Planning and Zoning Commission Agenda

Grimes Planning and Zoning Commission
October 7, 2025 @ 5:30 PM
Grimes Community Complex, 410 SE Main Street

DeCarlo Site Plan

RE: DeCarlo Site Plan

DIMENSION PLAN

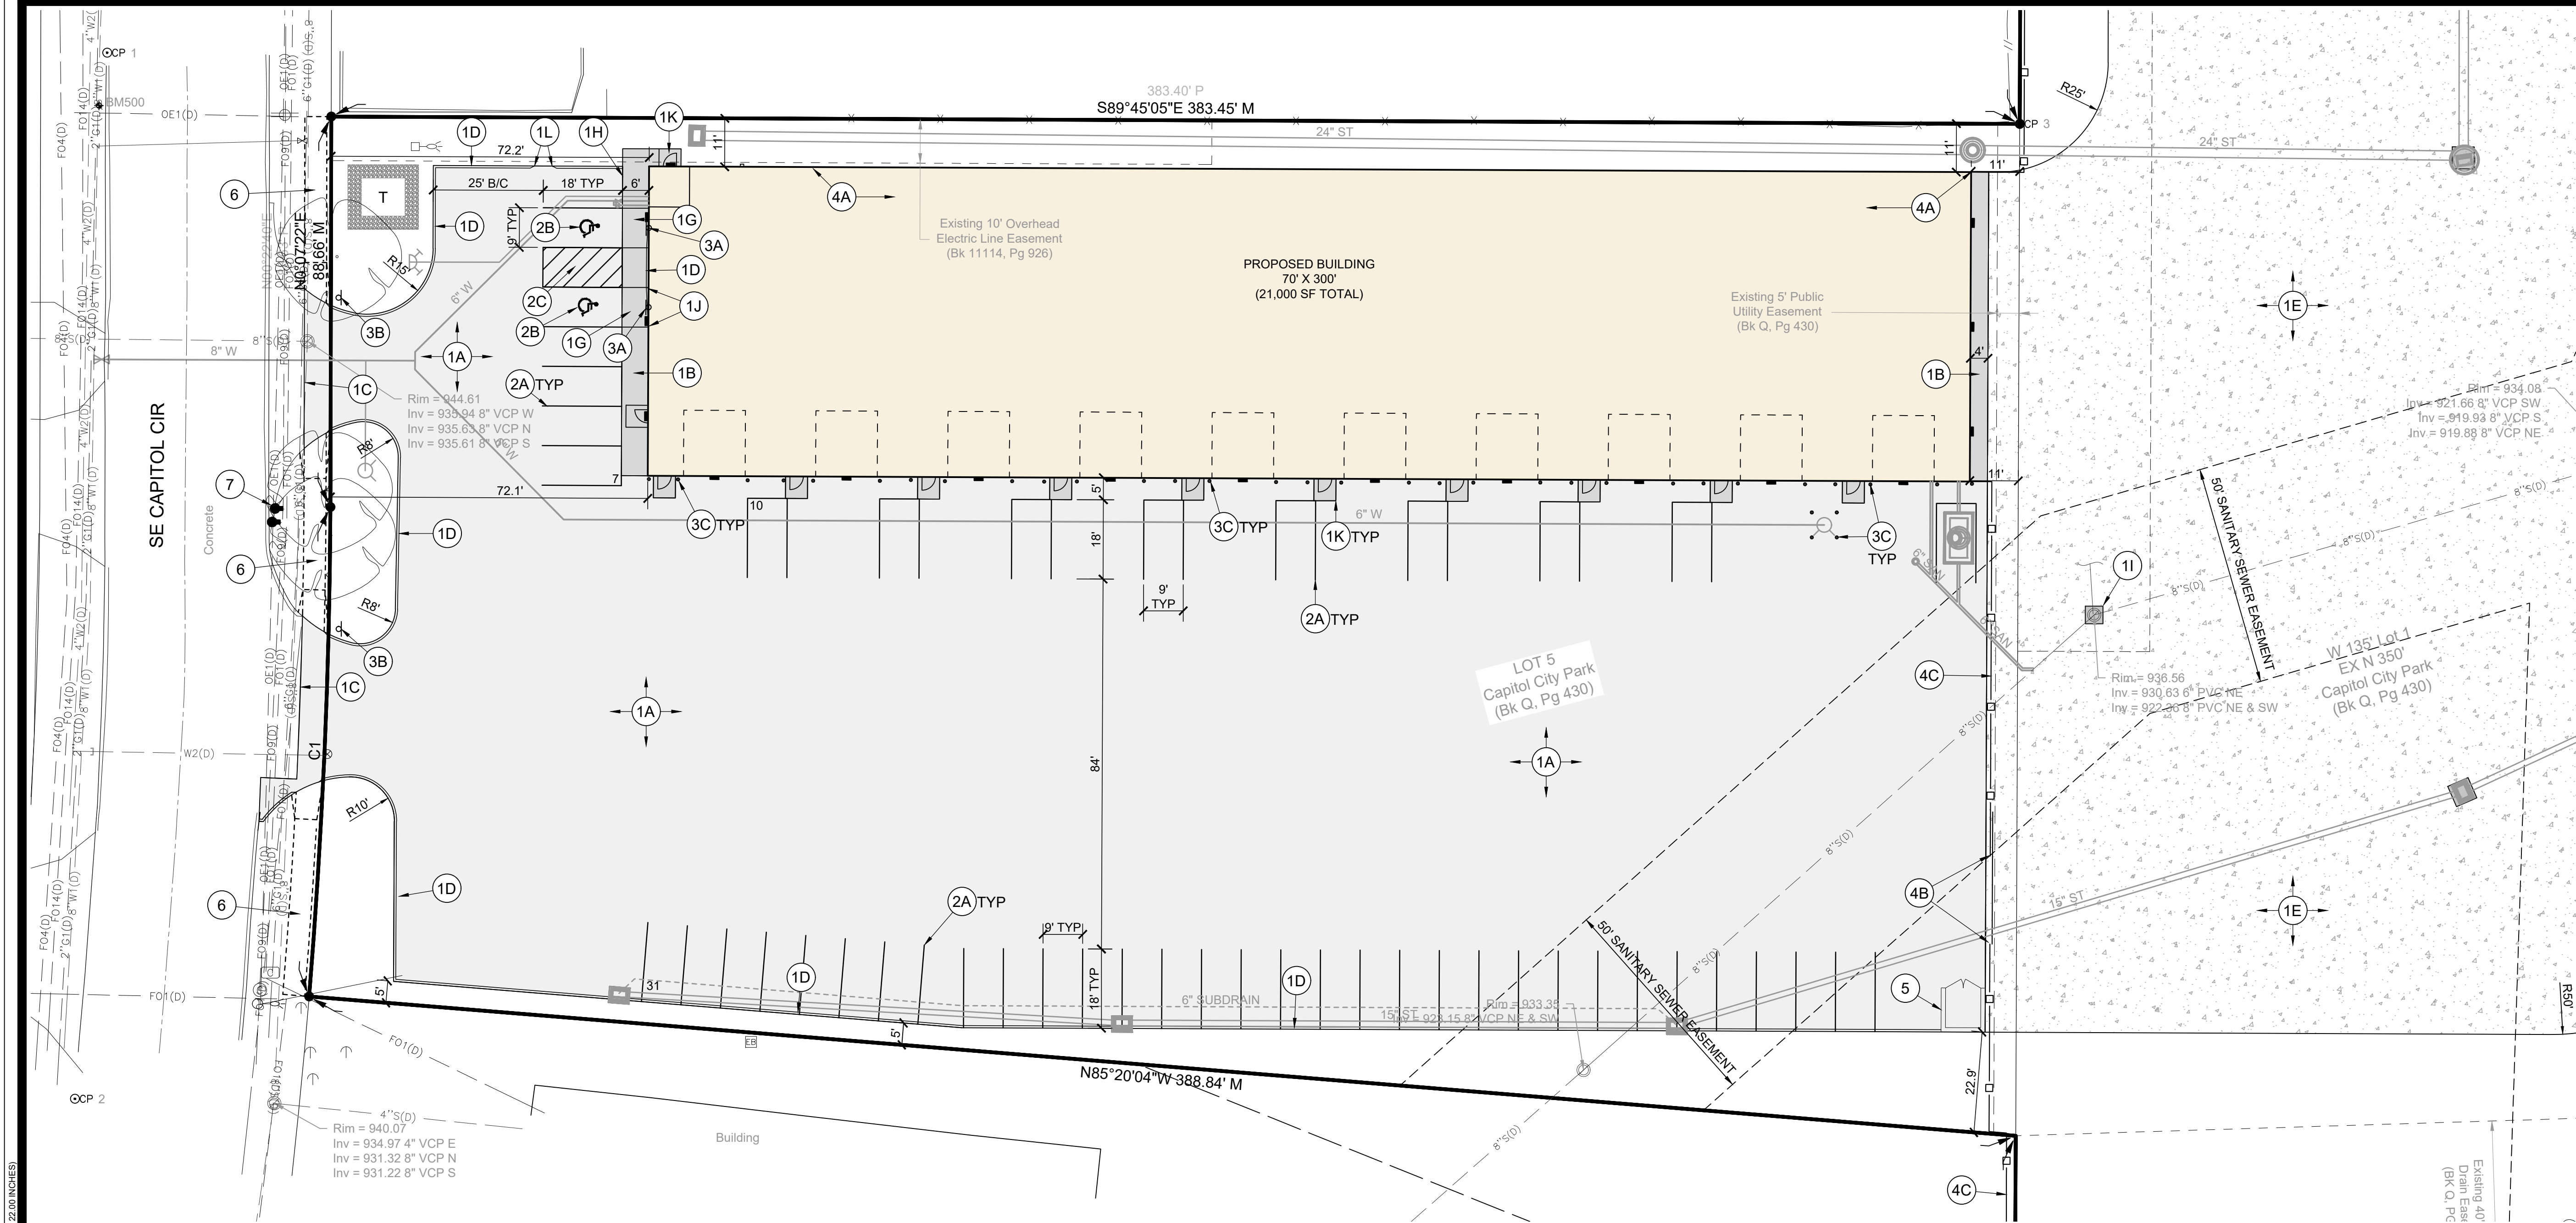
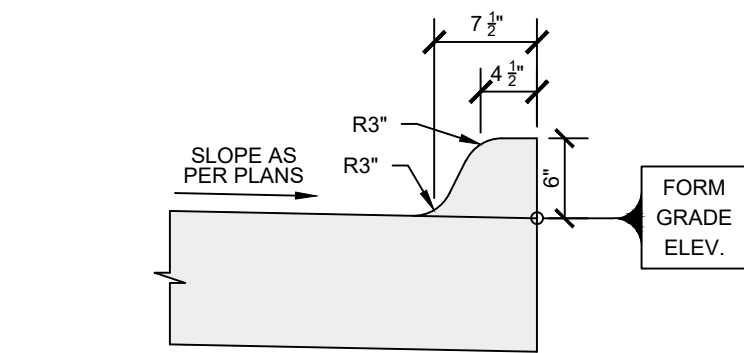
- ~~g. Gates intended for automatic operation shall be designed, constructed and installed to comply with the requirements of ASTM F2200.~~
7. Please provide SWPPP and filled out SWPPP review checklist in submittal.

- SITE AMENITIES, PROVIDE THE FOLLOWING:
 - 4" CONCRETE KNEE WALL.
 - 20' CANTILEVER SLIDE GATE, 6' HEIGHT OPAQUE METAL GATE. GATE SHALL MATCH METAL FENCE. INSTALL KNOX BOX WITH KEY FOR GATE. GATE SHALL COMPLY WITH THE REQUIREMENTS OUTLINED IN NOTE 8.

- GATES INTENDED FOR AUTOMATIC OPERATION SHALL BE DESIGNED, CONSTRUCTED AND INSTALLED TO COMPLY WITH THE REQUIREMENTS OF ASTM F2200.

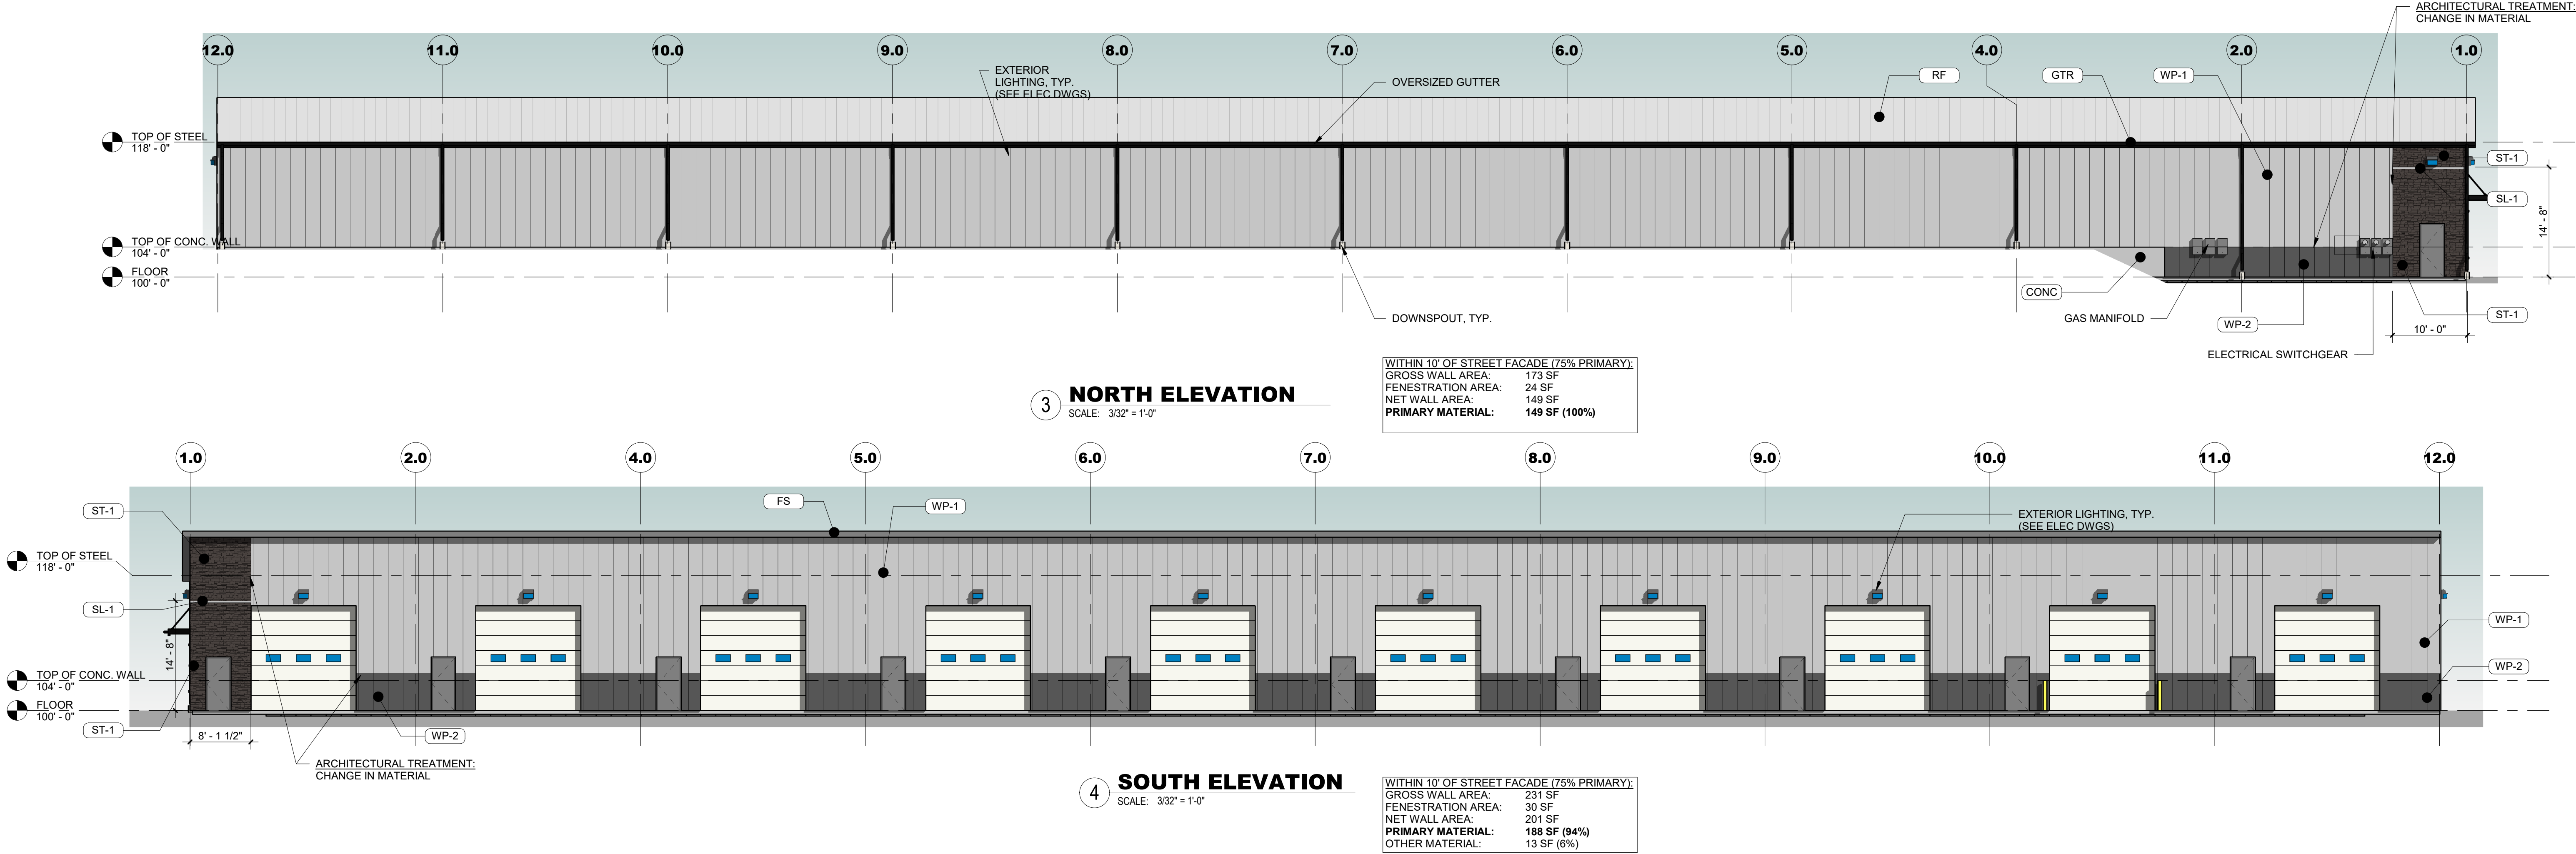
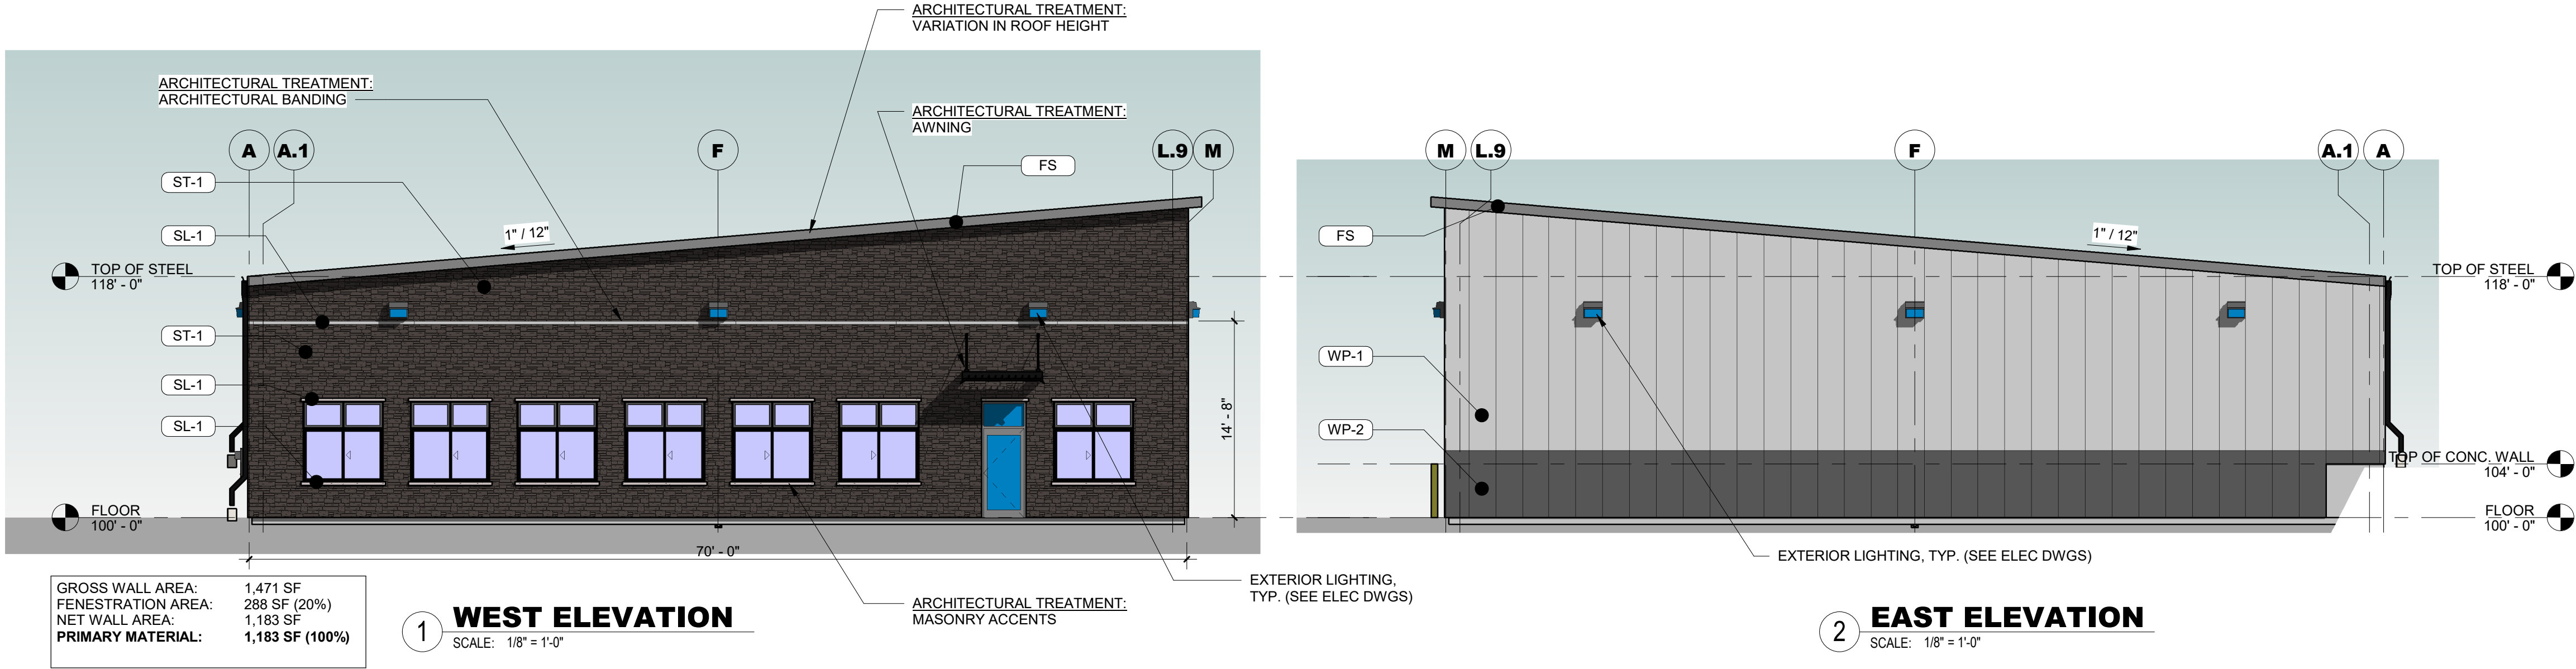
13. Please provide elevation for dumpster enclosure prior to Council meeting. Dumpster enclosure will need to be 100% masonry enclosure that matches the primary building with opaque gates due to it being visible from public street.
